## SERVICE BULLETIN

**SUBJECT:** ELECTRICAL POWER – Static Inverter AI<sup>2</sup> Model 1G1000-1A-2170, Part Number 1-002-0102-2170 – Modification.

**TRANSMITTAL:** Service Bulletin 1-002-0102-2170-24-47 Initial Release (Revision 0).

Figure 13 – Inverter board removed

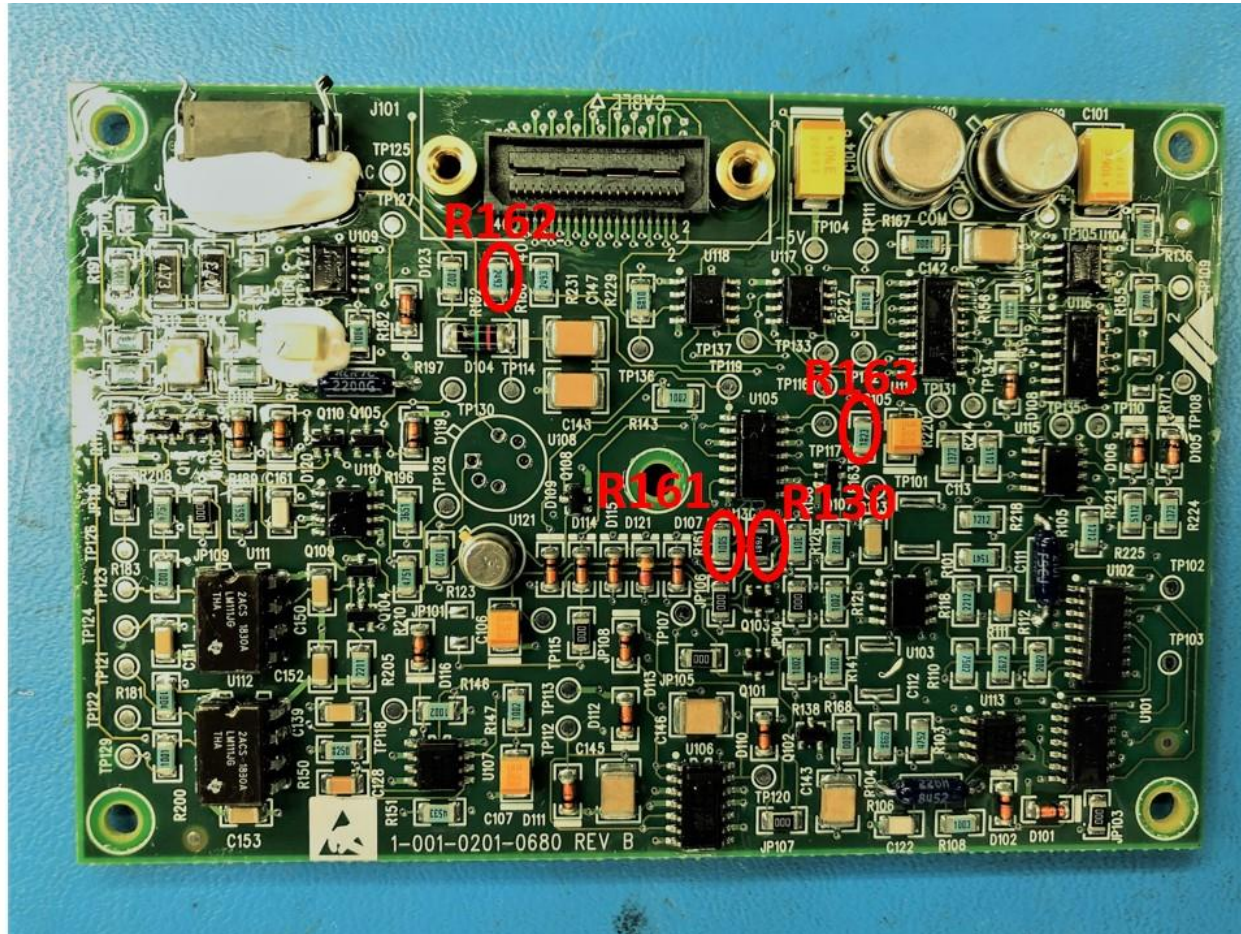
15. Remove (5) screws (5x MS51959-12) from shield. (Figure 10, 11).
16. Remove (2) screws (2x 0404CPP188) from inverter control. (Figure 12).
17. Locate resistors R130, R131 R162 and R163 on the inverter board. (Figure 13). (IPL Figure 26 items 225, 210 and 235).

18. Use solder tool to remove and replace resistors as follows:

Reference #	Original Part #	Replace with Part #
R130	1-001-0662-0023 (7.32k Ohm)	1-001-0662-0025 (7.68k Ohm)
R131	1-001-0662-0023 (7.32k Ohm)	1-001-0662-0013 (2k Ohm)
R162	1-001-0662-0007 (1k Ohm)	1-001-0662-0029 (10k Ohm)
R163	1-001-0662-0040 (68.1k Ohm)	1-001-0662-0129 (182k Ohm)
